DEVELOPMENT APPLICATION ASSESSMENT REPORT

Application Number:	DA2024/1036	
Responsible Officer:	Stephanie Gelder	
Land to be developed (Address):	Lot 1 DP 208499, 60 Cabarita Road AVALON BEACH NSW 2107 Lot LIC 556724, 60 Cabarita Road AVALON BEACH NSW 2107	
Proposed Development:	Construction of a swimming pool	
Zoning:	C4 Environmental Living	
Development Permissible:	Yes - Zone C4 Environmental Living No - Zone W1 Natural Waterways	
Existing Use Rights:	No	
Consent Authority:	Northern Beaches Council	
Land and Environment Court Action:	n: No	
Applicant:	Stephen Crosby & Associates Pty Ltd	
Application Lodged:	02/08/2024	
Integrated Development:	No	
Designated Development:	No	
State Reporting Category:	Residential - Alterations and additions	
Notified:	14/08/2024 to 28/08/2024	
Advertised:	Not Advertised	
Submissions Received:	0	
Clause 4.6 Variation:	Nil	
Recommendation:	Refusal	
Estimated Cost of Works:	\$ 30,800.00

Construction of a swimming pool and surrounding pool coping.

Figure 1. Extract of Survey Plan (prepared by Waterview Surveying Services dated 26 June 2024)

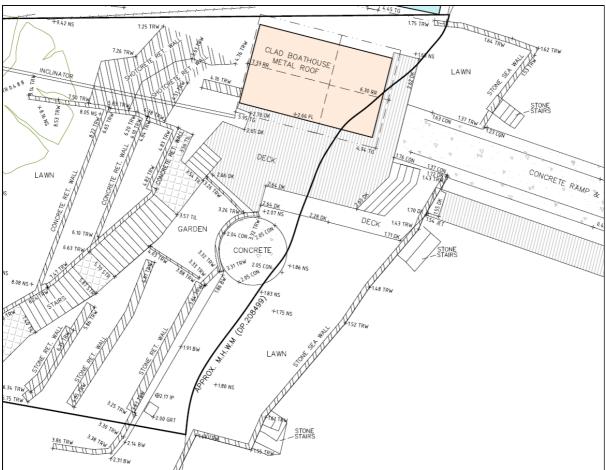
The Survey Plan submitted with the application (prepared by Waterview Surveying Services dated 26 June 2024) details the concrete slab upon which the pool is located is below the Mean High Water Mark (MHWM). It is acknowledged that an amended Survey Plan was emailed on 30 August 2024, however as this was not formally uploaded to the NSW Planning Portal. As such, the emailed Survey Plan does not form content of the development application as detailed under Clause 24(1)(c) of *Environmental Planning and Assessment Regulation 2021*.

It is noted that a portion of the proposed swimming pool that is located on top of the concrete slab is located below the MHWM (see Figure 1) and therefore located in Zone W1 Natural Waterways of Pittwater Local Environmental Plan

As such, the proposed swimming pool is prohibited in the Zone W1 Natural Waterways of Pittwater Local Environmental Plan 2014. The prohibition of the swimming pool in the Zone W1 Natural Waterways of Pittwater Local Environmental Plan 2014 will form part of the reasons for refusal.

The submitted Survey Plan details the concrete slab located below the mean high water mark. It is noted that the Master Plans are inconsistent with the Survey Plan and detail the concrete slab to be located wholly within the site boundaries.

For any works located below the mean high water mark, Owners Consent is required as the works are not located wholly within the subject site. In this instance, as Owners Consent has not been provided by the adjoining land owner, being Crown Land the proposal cannot be supported. The lack of Owners Consent will form part of the reasons for refusal.
